52-11-1 Emigh Applies to All Trojan A-2 Model Aircraft.

Compliance required by August 1, 1952.

FIGURE 1

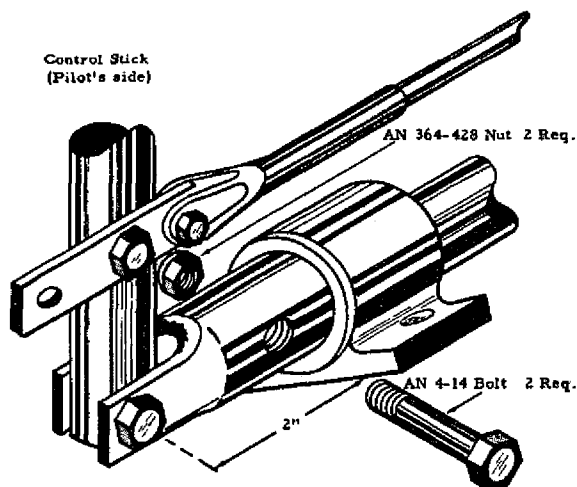
As the result of a reported failure of the welded joint in the elevator control tube socket, the following, or equivalent, should be accomplished, to preclude the possibility of recurrence of this type failure:

(a) Install a 1/4-inch AN steel bolt through the elevator control tube socket as shown in Figure 1 and secure with an elastic stop nut. Two installations will be necessary, one on the pilot's side and one on the passenger's.

(b) Due to the limited amount of clearance, it is recommended that the bolts be installed in the direction and location as shown. Ascertain that adequate clearance is provided when the control stick is operated throughout its full range.
